DESIGN REVIEW BOARD

April 13, 2016

DESIGN REVIEW BOARD STAFF REPORT

| Design Review Number: | 16-06-DRB | Meeting Date | April 13, 2016 |

SIDEWALK AT 112 UNION

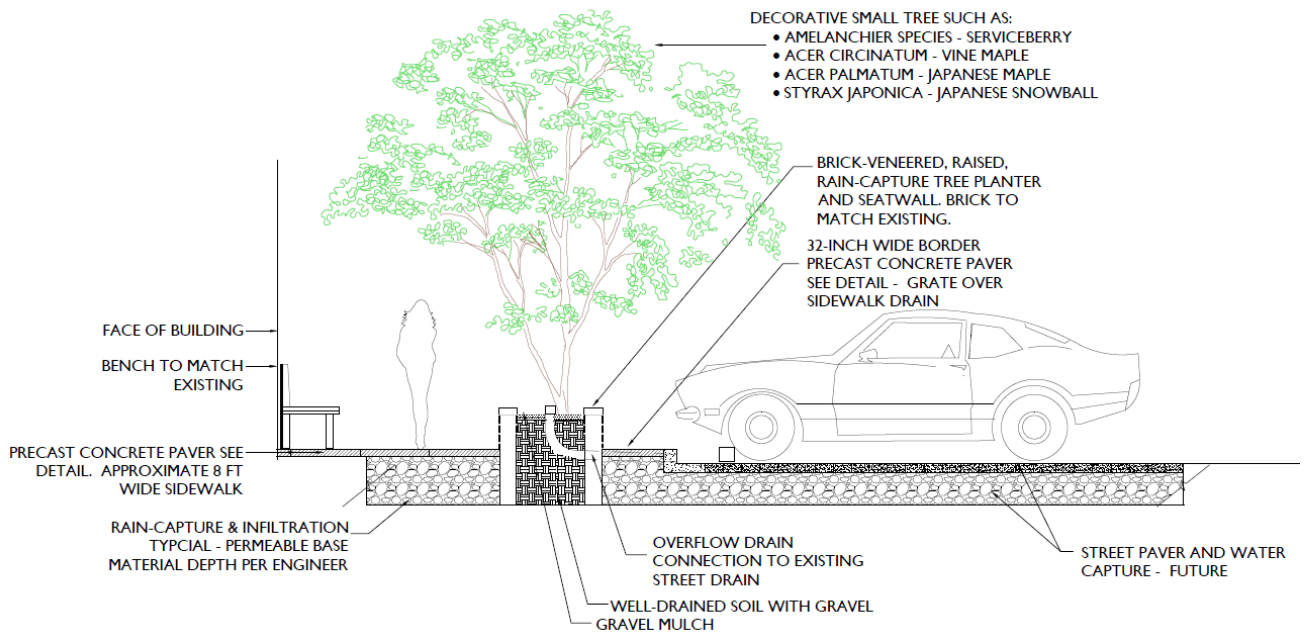
Staff comments: The existing sidewalk is approximately ten feet wide. The proposed planters and the seat will reduce the walkable area of the sidewalk. However, it appears to staff there is adequate pedestrian maneuvering area.

Staff comments: Six new street trees are proposed. The applicant is requesting guidance from the Board in making the final selection, however four small species have been identified for this project. These include: Amelanchier (serviceberry), Acer circinatum (vine maple), Acer palmatum (Japanese maple), and Styrax japonica (Japanese snowbell). Of these, the serviceberry and snowbell are among the approved trees in Appendix E of the Design Standards. The specific maple species are not, but may be considered similar to other maple varieties that are listed.

Staff comments: The proposal will further the standard with the planters flanking the new bench. Proposed plant species have not been identified.

Staff comments: The applicant has stated the permeable pavers will be a natural colored concrete with an exposed finish, to match adjacent weathered concrete sidewalks.

Proposed site plan

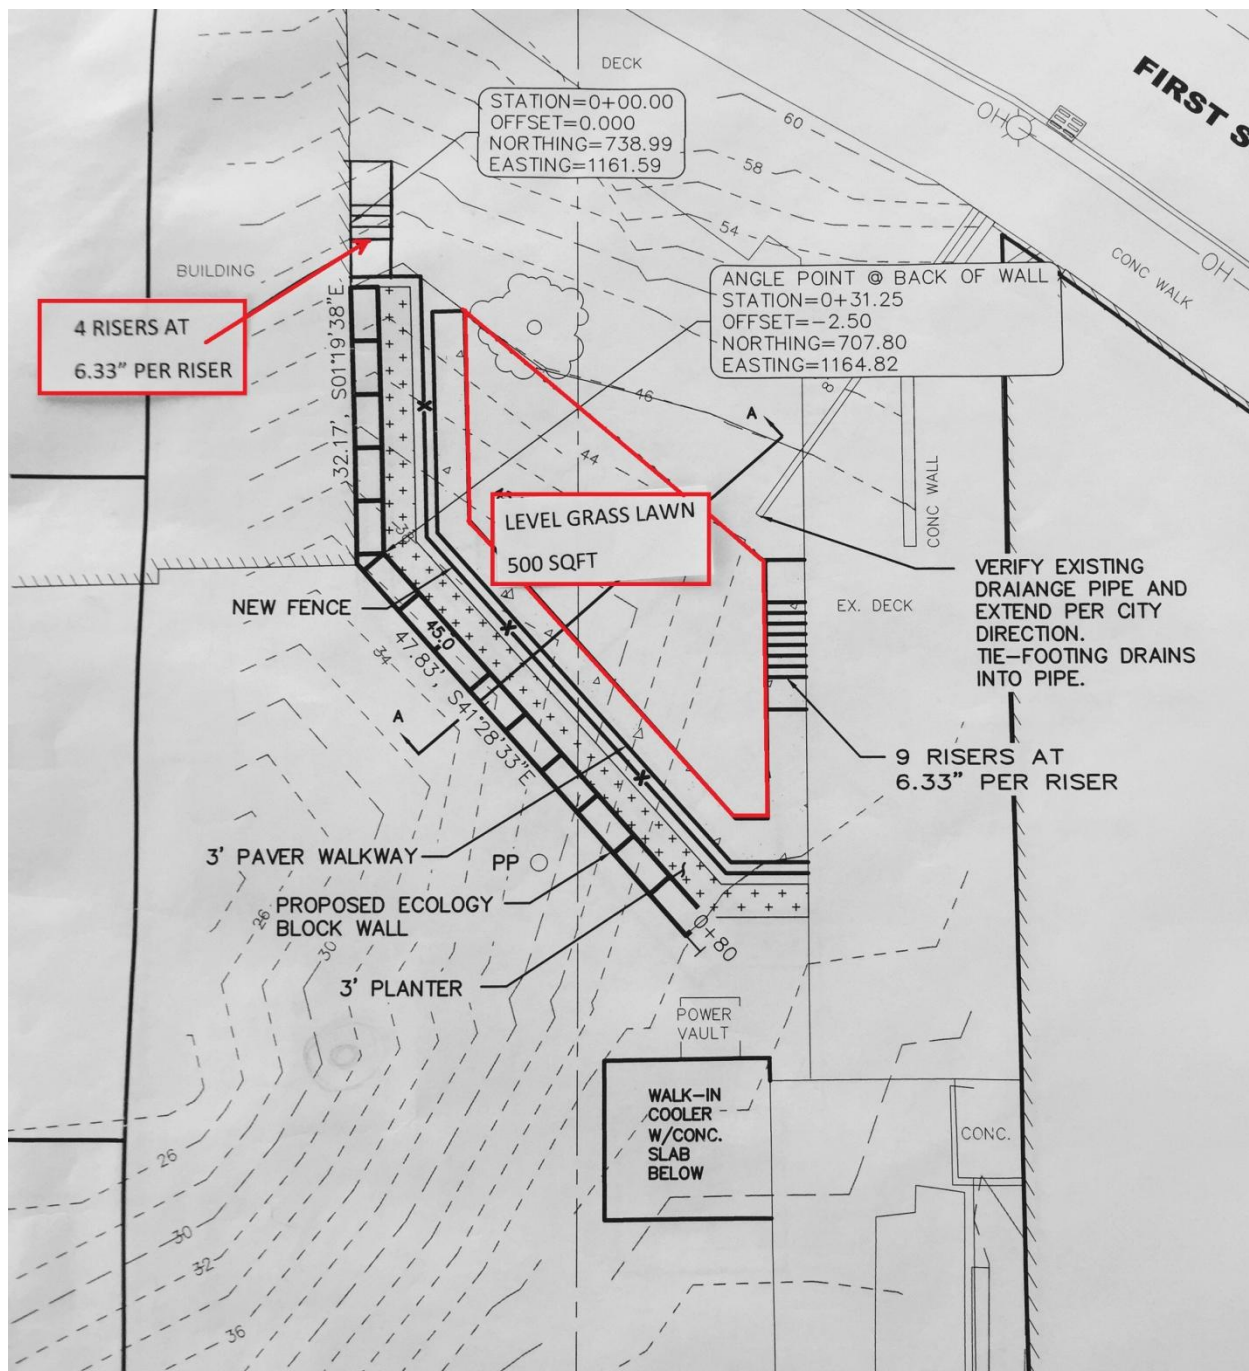
Staff comments: The proposed fence will match the previously approved fence at the overlook. The proposed ecology block wall will face the vegetated slope with a portion immediately adjacent to the building at 901 First Street. Staff would appreciate the Board's comment on whether the ecology block wall is consistent with the standard.

1. It appears the cooler pad is located directly adjacent to a large cedar tree. Is this tree proposed to be displaced by the cooler, or will it be preserved? Please describe how the roots will be protected during and after development, and any other measures to ensure the continued health of the tree.

2. Please describe all proposed plants for the new terraced area, particularly species contained in the 3-foot planter.

3. It is staff's understanding that the property owner to the west (901 First St) has requested accommodation of an access stairway in the right of way. Has the plan been modified to include this? If so, please submit those drawings, as the DRB will need to review them.

We are working with Rock Ash, an arborist with Ballard Tree Services in regard to the cedar tree.

As the Plan describes are landscape is the grass, (see drawing) also the new fence, the existing tree, and the textured ecology blocks. In the 3' planter will be something nice.

We met with Property owner (901 First Street) and have included their stairway design.

Staff image of approximate location of proposed outdoor cooler enclosure

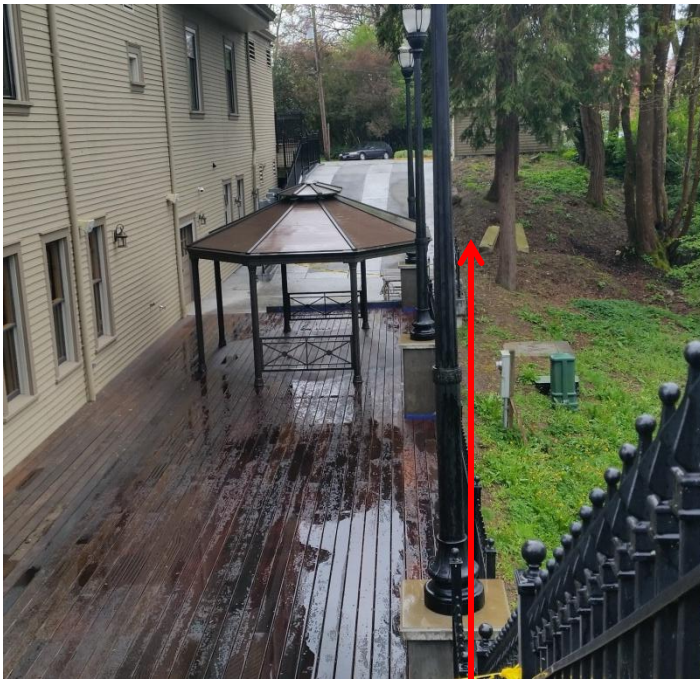
Staff comments: The proposed cooler pad is located immediately adjacent to a mature cedar tree. The applicant has stated he is working with an arborist regarding the tree, however has not clarified measures to preserve the tree.

4. What are the dimensions of the cooler enclosure, including height?

5. What style roof is proposed? What is the proposed roof slope? What are the proposed materials?

The dimensions for the cooler enclosure are 14'W x 15'L x 11.5'H

A parapet roof style is our design. A flat roof with a slant to the rear. Torch down is the material.

Existing front entry to be enclosed

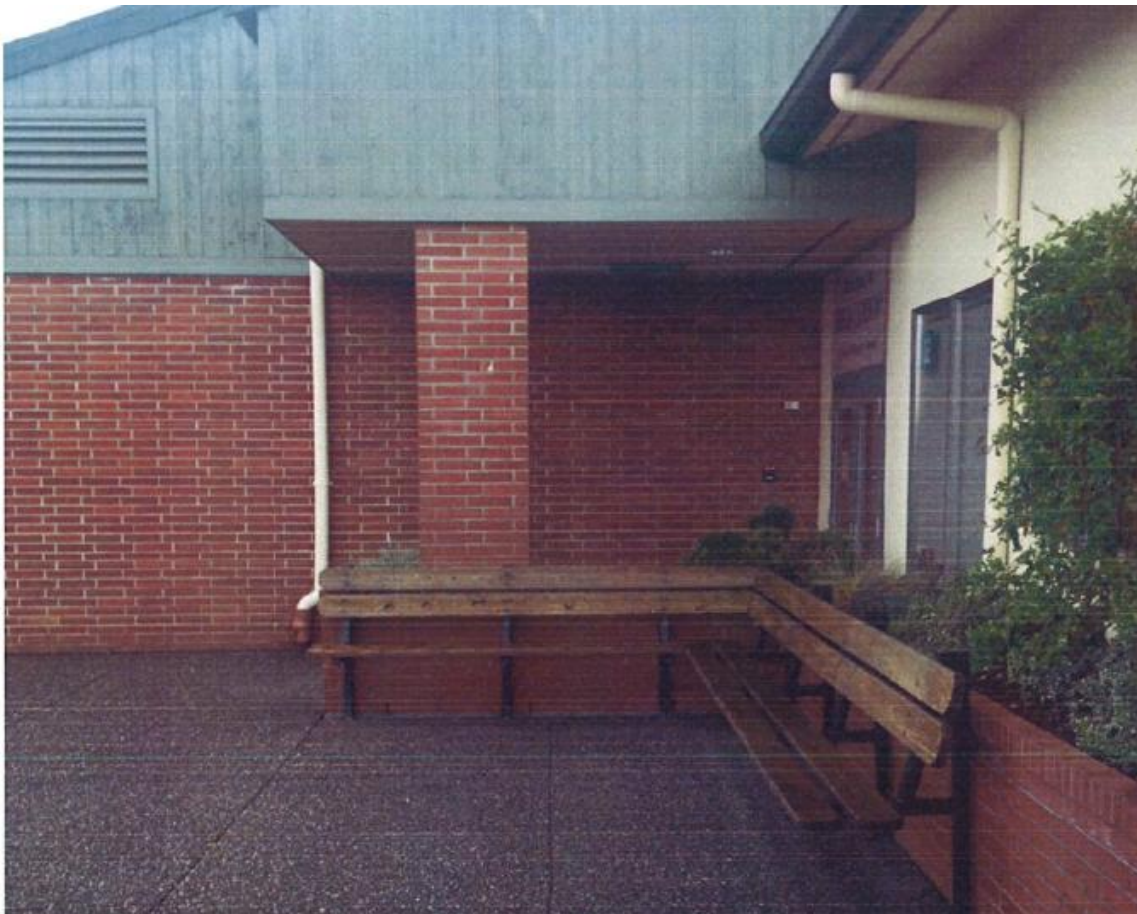
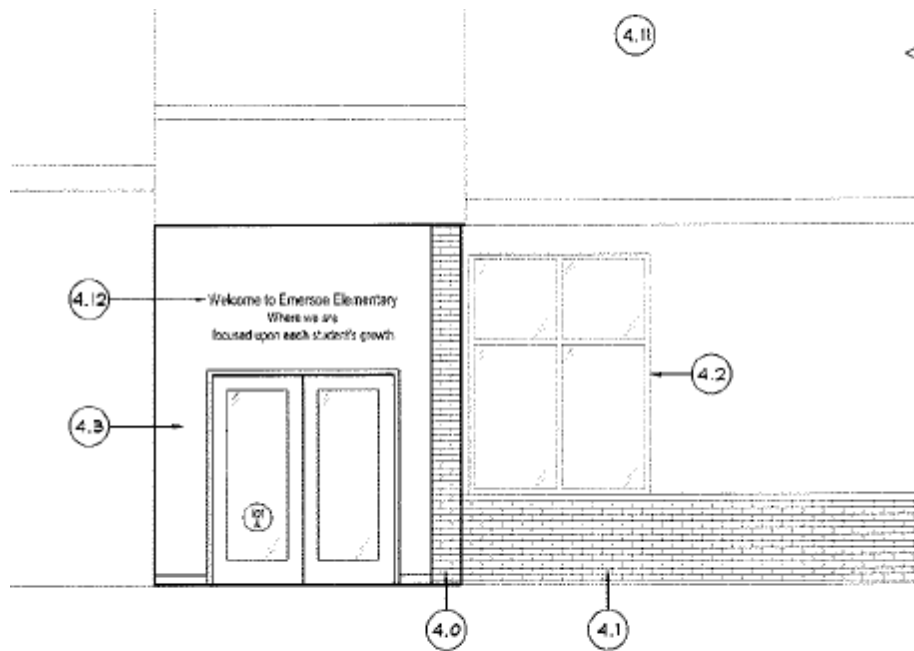
Staff comments: The proposed front entry will include a roof overhang from Group A (existing), and large entry doors from Group B. Existing brick elements and wood benches are consistent with Group C.

Staff comments: Both the front entry and the walkway have an existing base element with a low wall; brick at the entry and concrete at the walkway. The top element is also existing in both areas, as both areas are covered. The front entry has an overhanging roof element, while the walkway has a shed roof with a small eave.

1 MAIN ENTRANCE FRONT ELEVATION
1/4" = 1'-0"

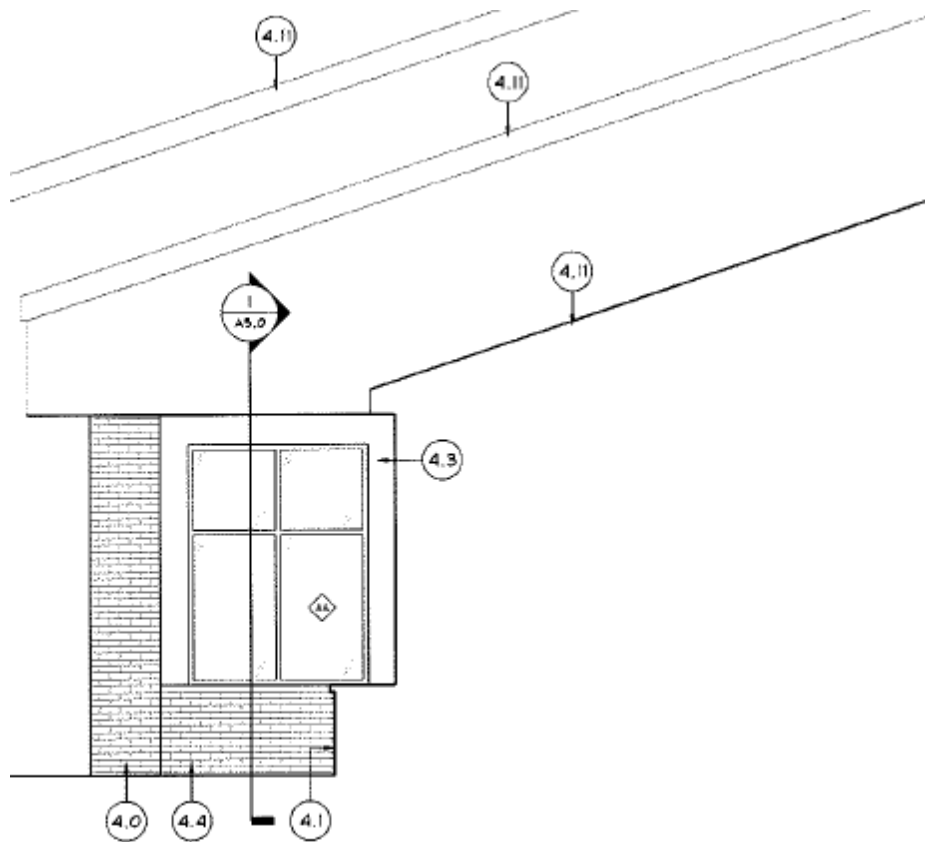
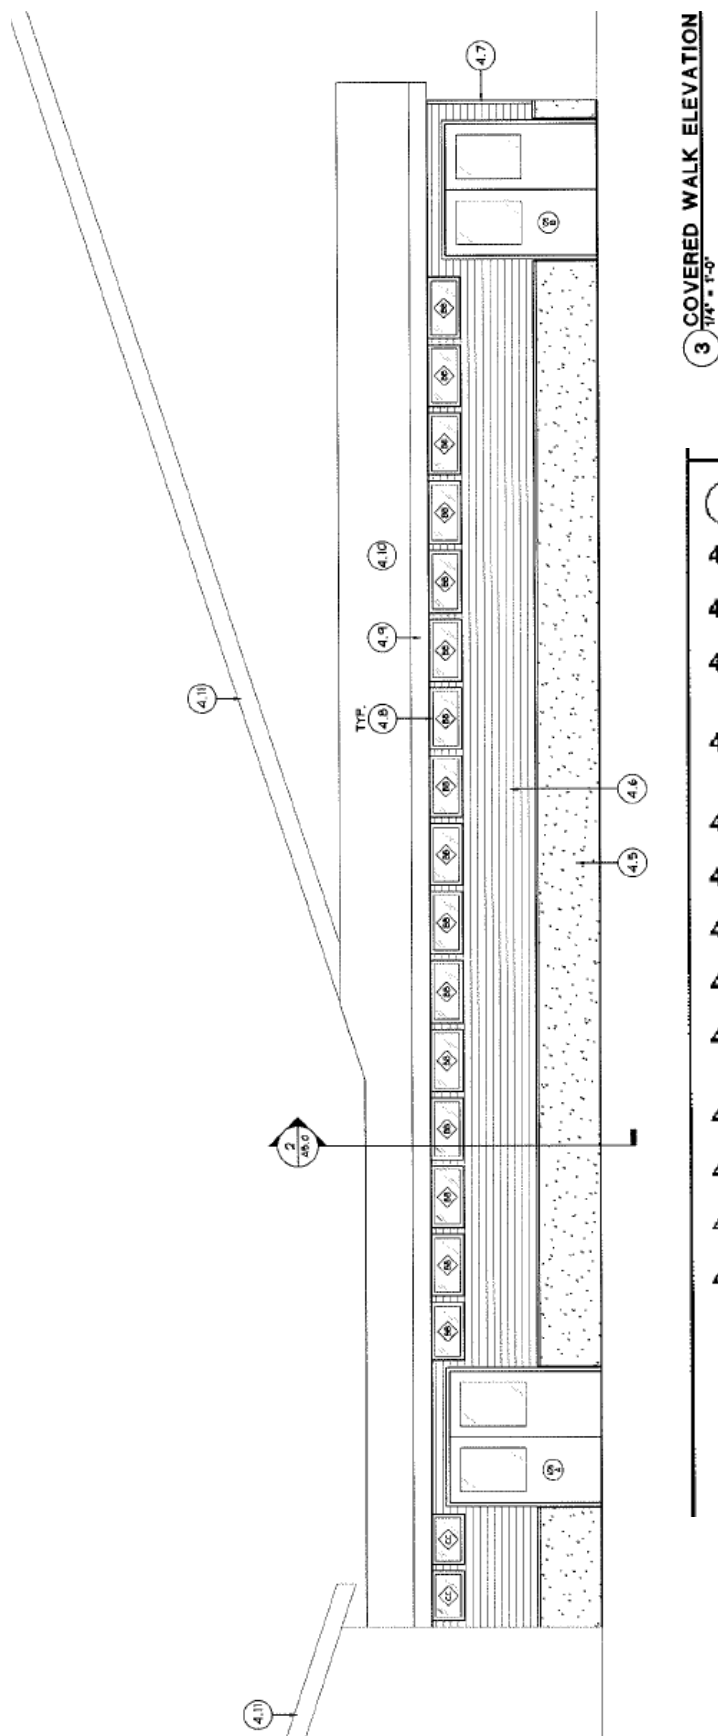
The front entry features an existing brick column and planter wall that will remain, with new walls faced in stucco siding. A new window is proposed on the side of the entry area. The proposed window is six feet wide by eight feet tall, aluminum safety glass. A glazed double entry hollow metal door is proposed with satin stainless steel hardware. The approximately 70 foot long covered walkway on the north side of the campus will also be enclosed. An existing low concrete wall will remain, with new wall area faced in cement fiber lap siding with a four-inch exposure and cement fiber corner trim. Two new half-glazed hollow metal double doors with satin stainless steel hardware are proposed at either end of the walkway. A row of 16 clerestory aluminum windows is proposed at the top of the wall. Proposed dimensions for the windows between doorways is two feet, ten inches wide and one and a half feet tall. Two narrower windows, two feet three inches in width are proposed on the far east side.

Staff comments: The walkway is in excess of 50 feet, and incorporates a concrete base with artwork (existing), changes in materials as well as color, and clerestory windows. The walkway faces the parking lot and athletic fields rather than a residential area or street.
